PRODUCT BULLETIN # 16571

Issue Date: 19-Jan-2011

TITLE: Shipping Tube change for SOIC Narrow Body (SOIC NB) devices and QSOP at ON Semiconductor Carmona, Philippines

Table1. Details for new tube

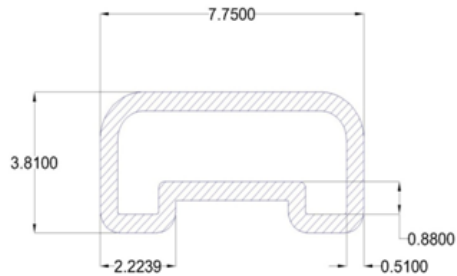
Description	YOSIKO Part Number	Drawing
ON 150 SOIC TUBE w/ RIBLINE	XONW Rev. E	 ON 150 SOIC TUBE W RIBLINE 20.6751 ii
ON 150 SOIC ENDPLUG	XEP-ON-17 Orig.	 ON 150 SOIC EP GREEN.XEP-ON-017-I

Figure1. Details of change

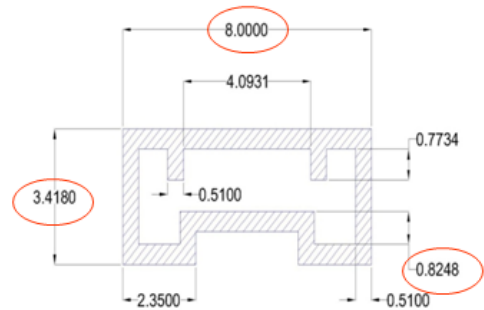
Length = 20.000 ± 0.050 inch
Supplier: ITW Ampang, Laguna, Philippines

Note: Dimensions in mm

Length = 20.6751 ± 0.050 inch
Supplier: YOSIKO, Bulacan, Philippines
